**Subject** **Port Heiden 2016 Groundwater Monitoring After-Action Report (Final)**

**Alaska Department of Environmental Conservation**  
**Comments on the Draft Tech Memo Groundwater Monitoring for Port Heiden RRS dated September 2016**  
**Commenter: Louis Howard (ADEC), Comments Developed: October 26, 2016**

### MONITORING WELL LOCATIONS AT FPC SITE 066

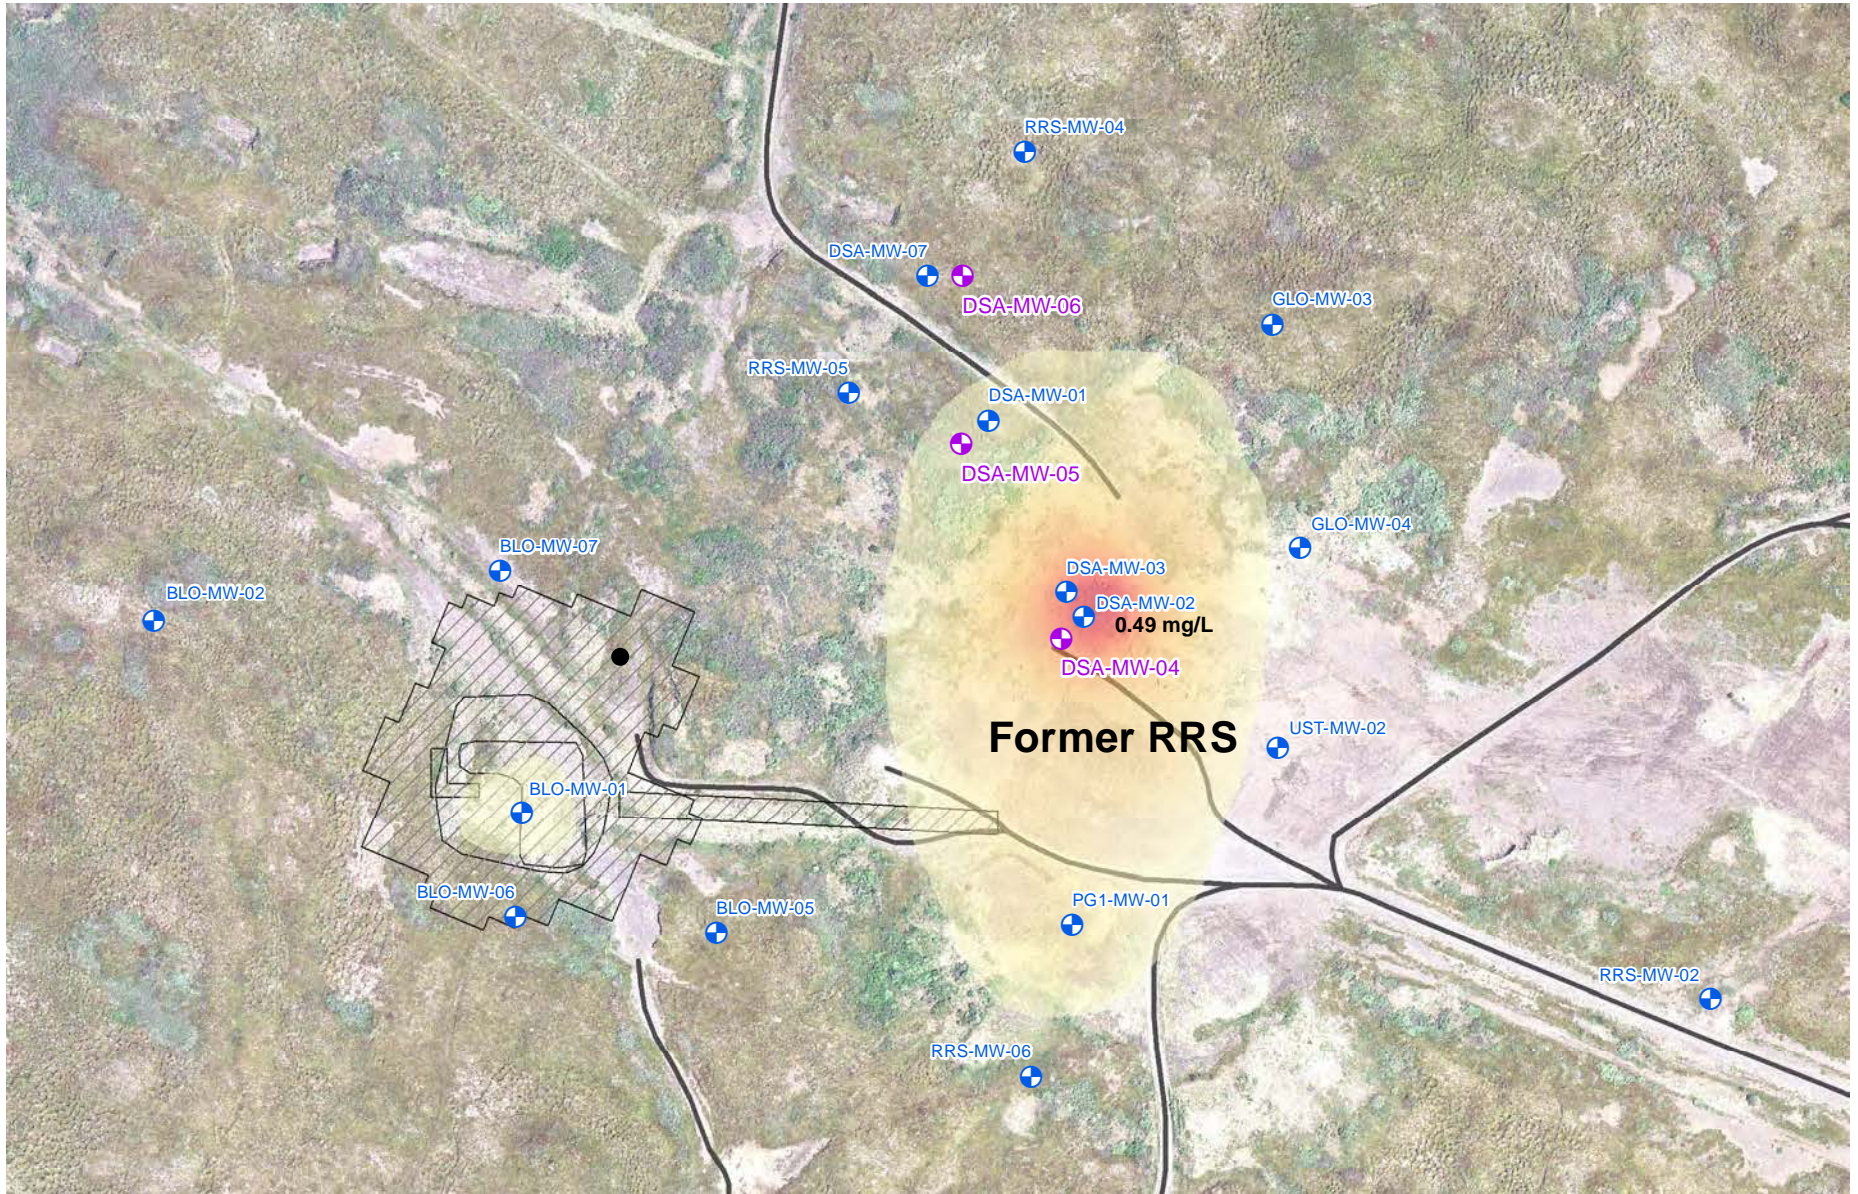
Cmt. No.	Pg. & Line	Sec.	Comment/Recommendation	Response
1.	3 of the PDF		<p><b>Conclusions</b>  The text states: “Sample results from three downgradient monitoring wells (066-MW-04, 066-MW-06, and 066-MW-07) no longer exceed the groundwater cleanup levels indicating that the DRO plume is stable and likely decreasing in concentration overall.”</p> <p>ADEC requests clarification on whether the above wells have just reached cleanup levels in the most recent sampling round or have met in for several years of sampling. Please provide additional text on the exact year of when the wells have been below Table C cleanup levels or a table (more preferable) with the wells and specific lab results as in done for Table 1 for each of the wells.</p> <p>The text states: “Based on these results, the USAF recommends that long-term monitoring of Monitoring Well 066-MW-05 be conducted until two consecutive sampling events report DRO concentrations below the ADEC Table C groundwater cleanup level (ADEC 2016). These sampling events should alternate between spring/summer and fall/winter timeframes to account for seasonal fluctuations. The USAF also recommends that the sampling frequency be reduced to once every 5 years to coincide with the 5-Year Review cycle.”</p> <p>ADEC disagrees. Instead the groundwater sampling shall be conducted every year until the next five year review (May 2019) with the next sampling event to be conducted in October 2017, June 2018 and October 2019. At that time, the data will be evaluated to see if there is indeed a summer/fall fluctuation and the monitoring can be reduced to every five years or eliminated completely if there are two consecutive sample results below Table C cleanup level for diesel range organics.</p>	<p><b>Agreed.</b> Table 1 will be revised to include the DRO results from the FPC-066 wells from 2009 through this sampling event. A copy of this table is included with this comment-response form for review.</p> <p><b>Agreed.</b> The recommendation will be revised as follows:  “Based on these results, the USAF recommends that long-term monitoring of Monitoring Well 066-MW-05 be conducted until two consecutive sampling events report DRO concentrations below the ADEC</p>

Cmt. No.	Pg. & Line	Sec.	Comment/Recommendation	Response
			<p>One year prior to the five-year review, wells 66-MW-04, 66-MW-07, 66-MW-06 shall be sampled (in June 2018) for DRO in addition to 66-MW-05.</p> <p>Please clarify whether or not the wells were ever sample for PAHs (Method 8270 and 8270-SIM), GRO (AK 101), BTEX (Method 8260). If so, include the historical results when reporting sampling from June 2018. If not, then add these analytes and laboratory methods to the draft work plan that will be submitted no later than April 1, 2018 for review, comment and approval. Well 66-MW-06 shall also be sampled for BTEX, GRO, PAHs at this time.</p> <p>Also state in the text when the next five-year review will be conducted: "The next five-year review will be completed by May 2019."</p> <p>Based on the information provided, ADEC concurs with the conclusion that 1,4-dioxane sampling is no longer necessary for the site.</p>	<p>Table C groundwater cleanup level (ADEC 2016). These sampling events will alternate between spring/summer and fall/winter timeframes to account for seasonal fluctuations. Sampling events will be scheduled for October 2017, June 2018, and October 2019 when the next five-year review will occur (May 2019). At that point the data will be evaluated to determine if there is indeed a summer/fall fluctuation and if monitoring can be reduced to every five years or eliminated completely if there are two consecutive sample results below the ADEC Table C cleanup level for DRO. In the year prior to the five-year review (June 2018), Monitoring Wells 066-MW-04, 066-MW-06, and 066-MW-07 will also be sampled for DRO."</p> <p><b>Clarification.</b> During the RI both soil and groundwater samples from the FPC-066 site were analyzed for GRO, DRO, RRO, VOCs, PAHs, and metals. Only DRO exceeded the cleanup level. The current wells were installed during the 2009 Groundwater Investigation and the groundwater and soil samples</p>

Cmt. No.	Pg. & Line	Sec.	Comment/Recommendation	Response
				<p>were analyzed for GRO, DRO, RRO, and BTEX. Again only DRO was found to exceed cleanup levels. As part of the 2009 Groundwater Investigation Report all stakeholders agreed that DRO is the only contaminant of concern and the analytical suite could be limited to DRO only going forward.</p> <p><b>Agreed.</b> The sentence “The next five-year review will be completed by May 2019.” Will be added as suggested.</p>
